# CITY OF ALBUQUERQUE

RE: **Prima Entrada Lots 1-7**  
**9500 Sonterro Ave NW**  
**Grading and Drainage Plan**  
**Engineer's Stamp Date: 5/6/19**  
**Hydrology File: J09D020A**

Based on the submittal received on 5/6/19, this Grading and Drainage Plan cannot be approved until the following are corrected:

1 SECTION AT PROPERTY LINE Scale: 1:5

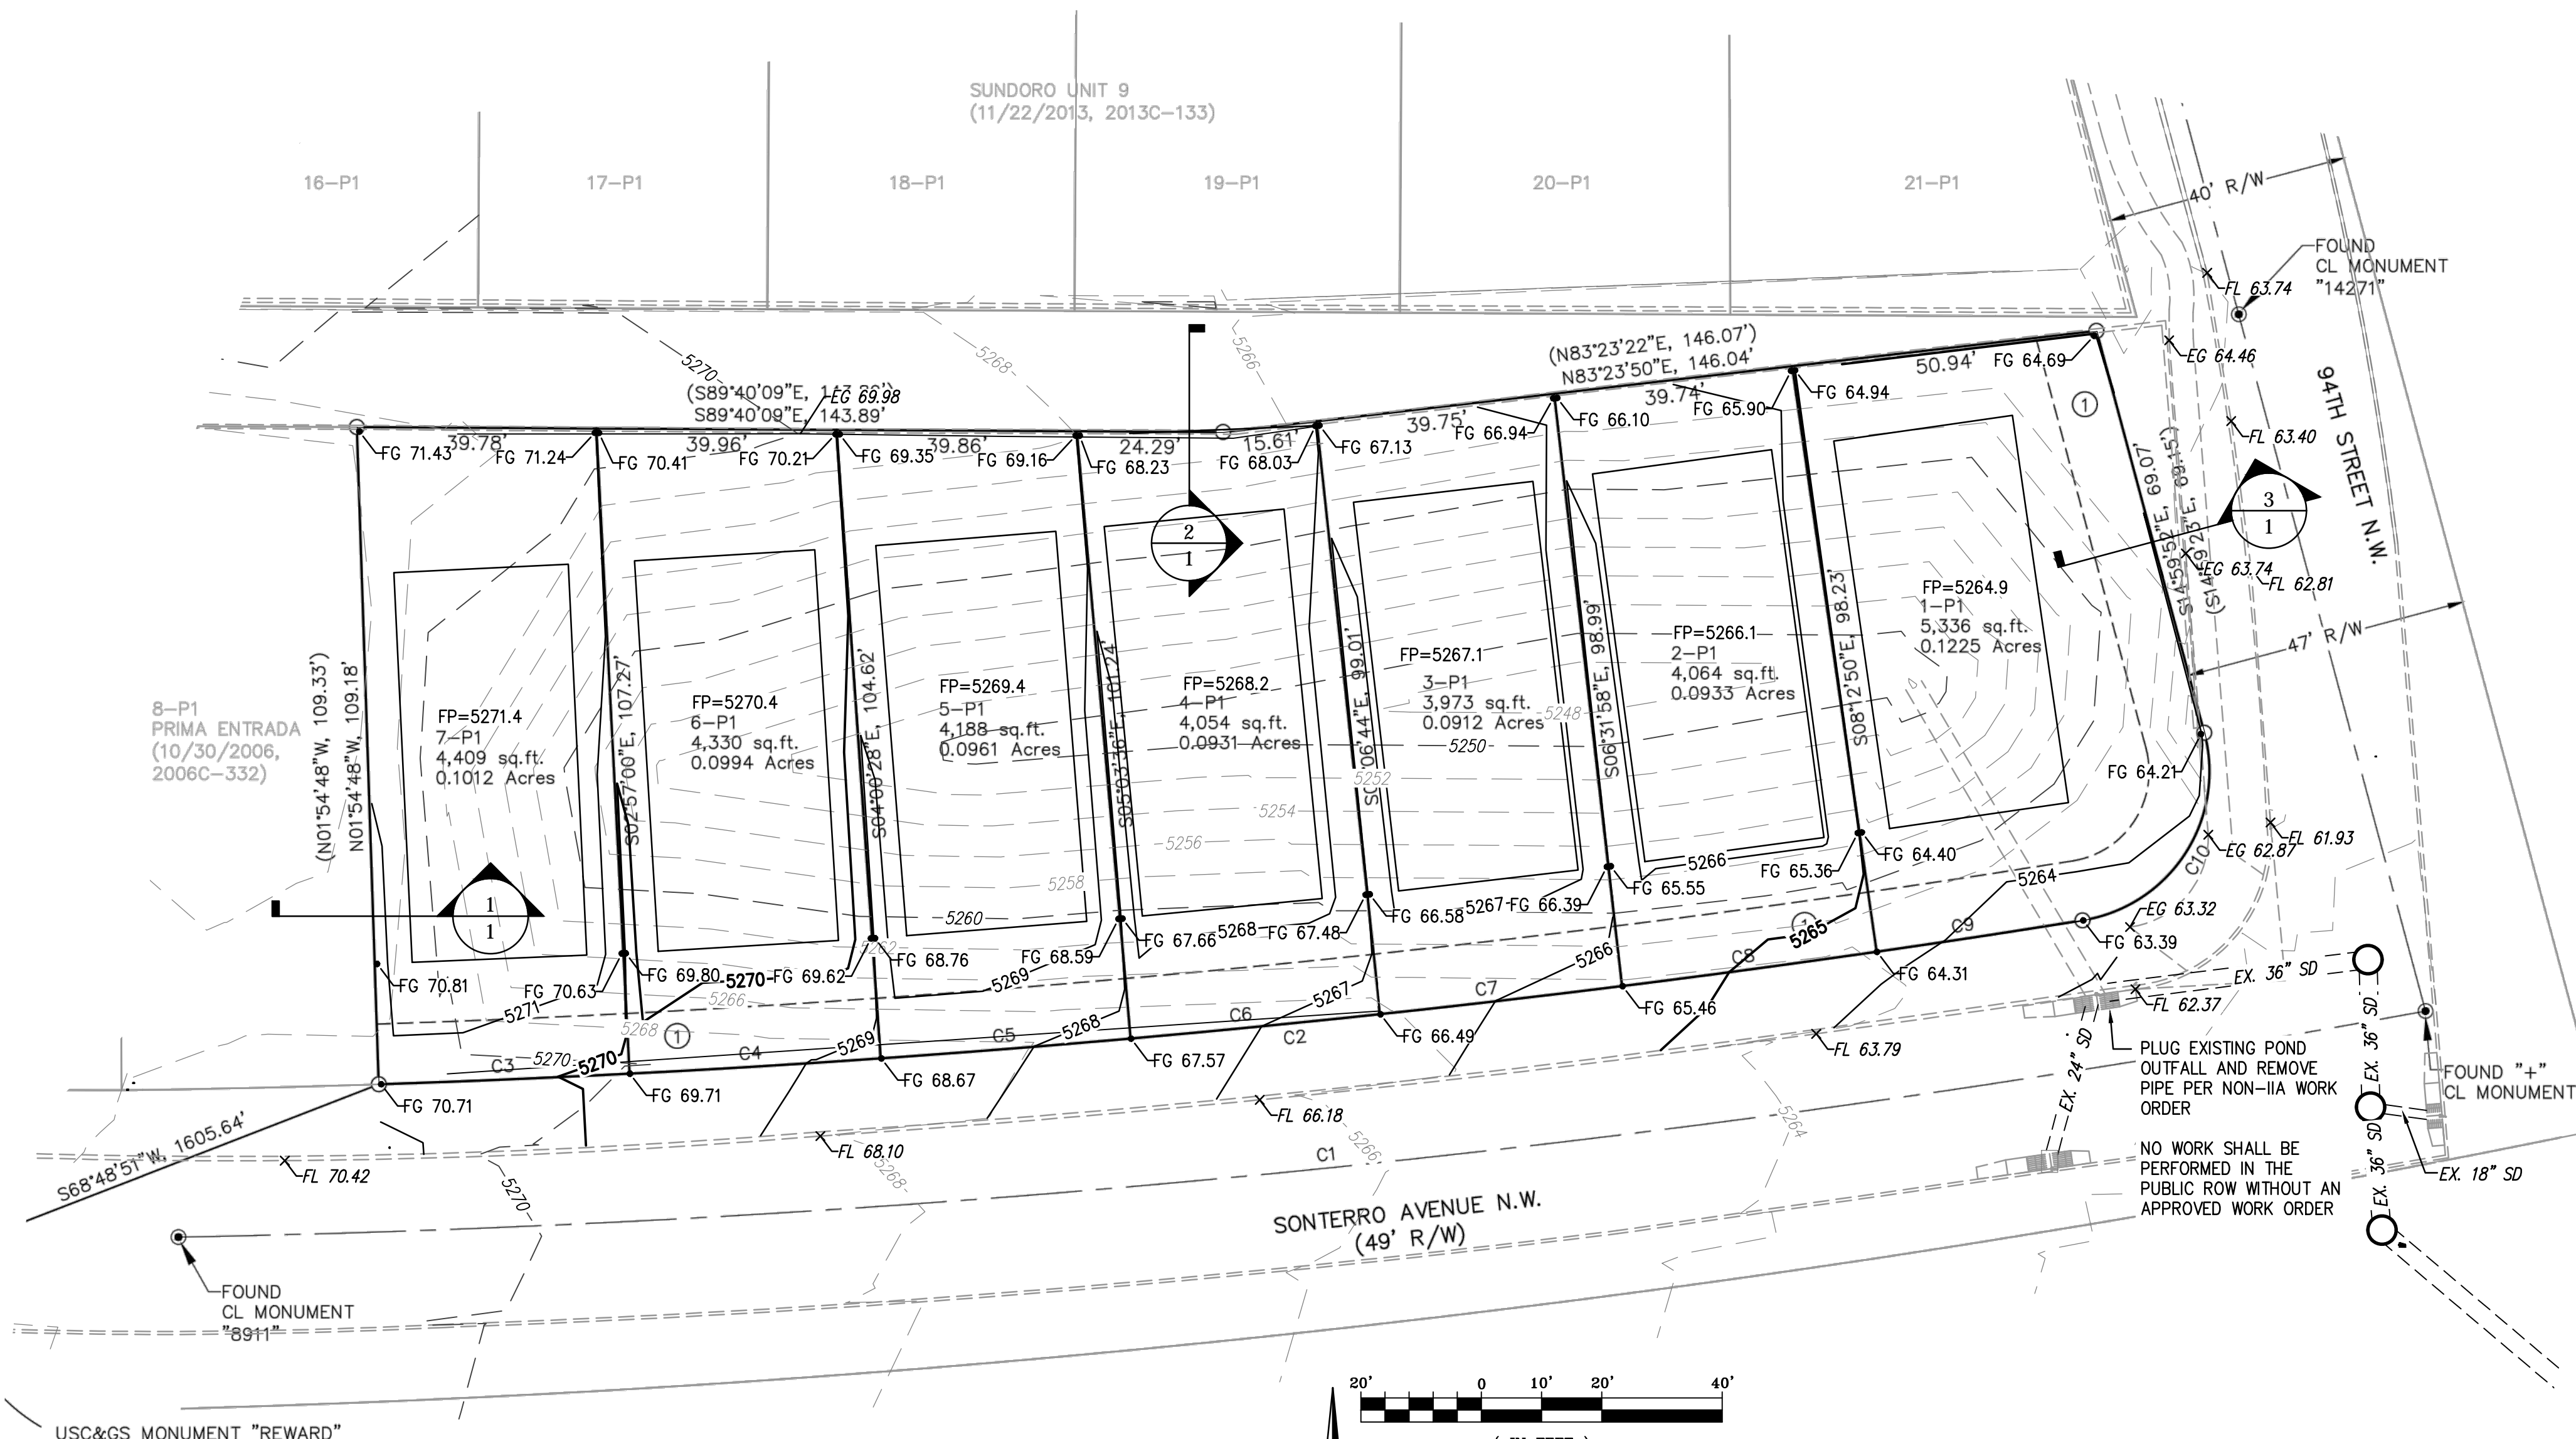
- a. Section 1-1 does not show property line and the wall should be called out as proposed. Hydrology recommends specifying a max permissible grade change (~18" for garden wall); right now the plan indicates that no grade change is allowed.

- b. Section 1-2 does not show property line. This existing wall appears to have a retaining wall at its base; please confirm. The max permissible grade change should be specified for cut and fill, as both cases will occur per your grading plan.

- c. Section 1-3 does not show property/ROW line. This wall was built in the ROW and will need to be removed and rebuilt on private property as part of this project. Alternatively, you can obtain a Revocable Permit for the encroachment (prior to Final Plat) or vacate the ROW (Prior to Final Plat). The plan needs to show which option will be pursued. Hydrology recommends specifying a max permissible grade change (~18" for garden wall); right now the plan indicates that no grade change is allowed.
